ITEM V-B: DESIGN REVIEW PERMIT – 1351 SECRET RAVINE PW. – SUTTER ROSEVILLE MEDICAL OFFICE BUILDING (MOB) 6 AND PARKING GARAGE – FILE #PL13-0284

REQUEST

The applicant requests approval of a Design Review Permit to allow the construction of a 60,000 square foot medical office building and a five-story 475 space parking garage. Both building sites include frontage improvements, lighting and landscaping.

Figure 2: Campus Site Plan

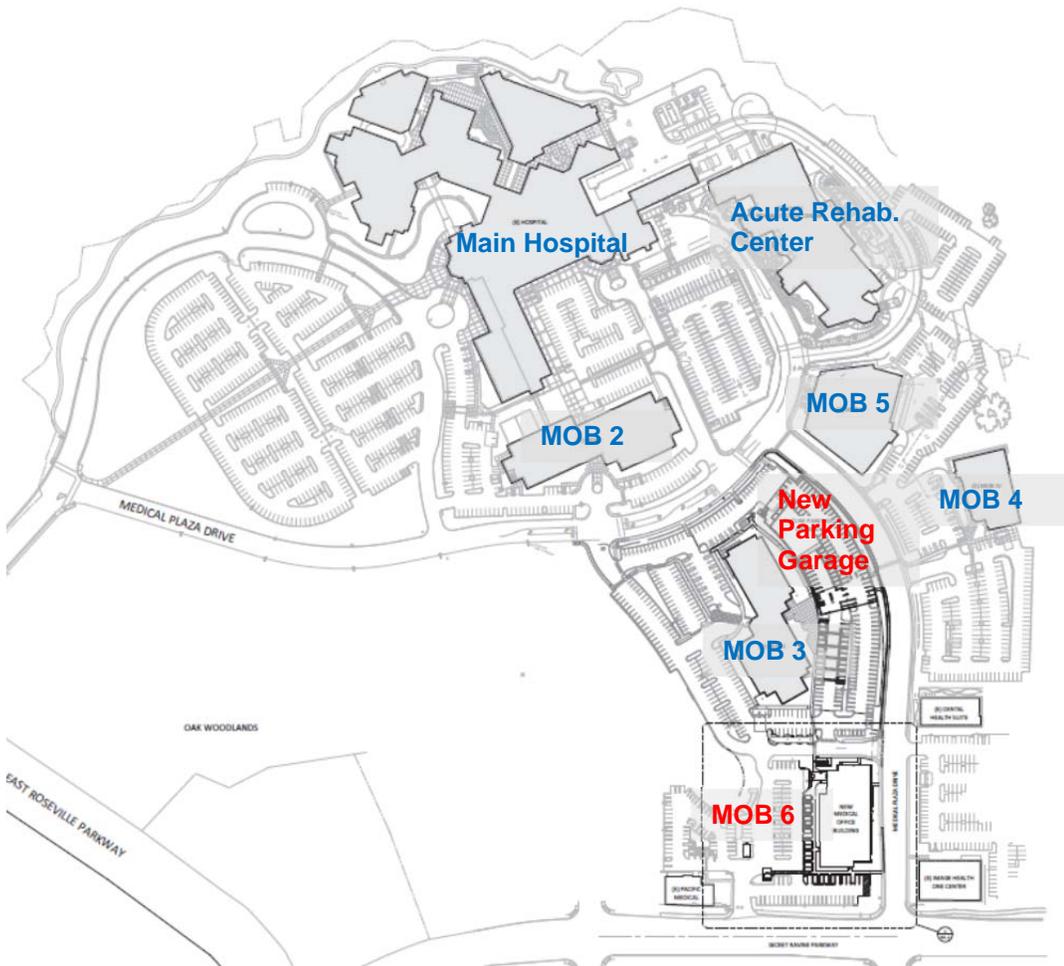
Staff evaluated the project for consistency with the approved campus master plan (Attachment 1) and found that the proposed project is within the scope of the plan. The master plan anticipated 361,500 square feet of medical office buildings on the campus. After the MOB 6 project is constructed, an

estimated 76,943 square feet of medical office space would be left to be developed in the future. The proposed parking garage will replace parking garage 8 on the campus master plan in a slightly different location, where MOB 11 & 12 were anticipated to be constructed. Given the fact that the overall campus will still be within the approved building square footage for medical office, staff does not anticipate impacts to traffic, circulation, utilities or other project related impacts. Some of these issues are discussed in more detail below.

One area of note, is that the relocation of buildings will require the applicant to modify the project parcel boundaries through a lot line adjustment. This requirement has been added as Condition #4 of the Design Review Permit.
